# Access Compliance Report

## Public Rights-of-Way

### (Curb Ramps)

Intersection ID: 46689	Main Street: GOLDFIELDS_DR	Cross Street: NIGHTSHADE_OAKS_DR	Location: SE
ADA ID: 6A9B496CC577	Ramp Type: PerpDiag	Initial Pass/Fail: Fail	Overall Compliance: No
Severity Score: 13.75			
Codes/Mitigation Info/Possible Solution		Field Measurements/Component Compliance

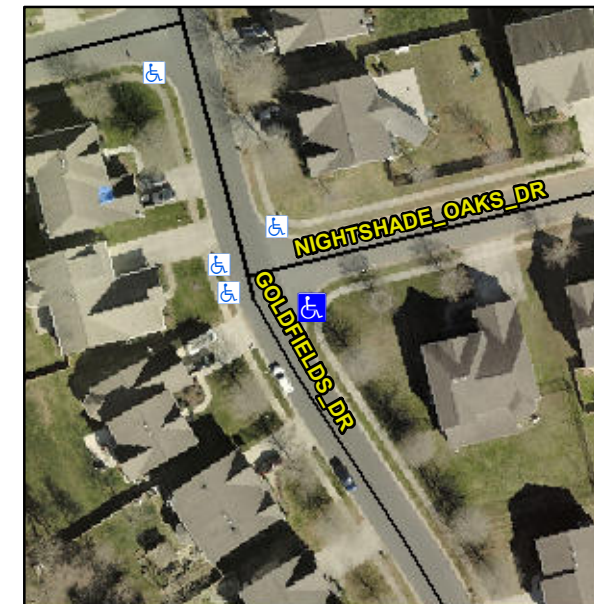
**Not Found, R304.2.2, R304.5.3**

Compliance	Description	Data	Compliance	Description	Data
N/A	Ramp Length (in)	48.0	No	Ramp Slope (%)	9.6
Yes	Ramp Width (in)	48.0	No	Ramp XSlope (%)	3.8
N/A	Flare Type LT	N/A	N/A	Flare Type RT	N/A
N/A	Flare Slope LT (%)	N/A	N/A	Flare Slope RT (%)	N/A
N/A	Flare Traversable LT?	N/A	N/A	Flare Traversable RT?	N/A
N/A	Landing Length (in)	N/A	N/A	DWS Provided?	N/A
N/A	Landing Width (in)	N/A	N/A	DWS Contrast?	N/A
N/A	Landing Slope (%)	N/A	N/A	DWS Length (in)	N/A
N/A	Landing X Slope (%)	N/A	N/A	DWS Full Width?	N/A
N/A	Landing Curb? (Y/N)	N/A	N/A	DWS Offset (in)	N/A
N/A	Shared Landing?	N/A			
N/A	Gutter Ponding?	N/A	N/A	Gutter Slope (%)	N/A
N/A	Gutter Lip Ht (in)	N/A	N/A	Gutter X Slope (%)	N/A
N/A	Painted X Walk1?	No	N/A	Painted X Walk2?	No
	X Walk 1 Direction	To NE		X Walk 2 Direction	To NW
N/A	X Walk 1 Width (in)	N/A	N/A	X Walk 2 Width (in)	N/A
	X Walk 1 Slope (%)	2.2		X Walk 2 Slope (%)	4.7
	X Walk 1 X Slope (%)	0.5		X Walk 2 X Slope (%)	2.3

**Remove & Replace Curb Ramp With Two New Directional Ramps or Equivalent.**
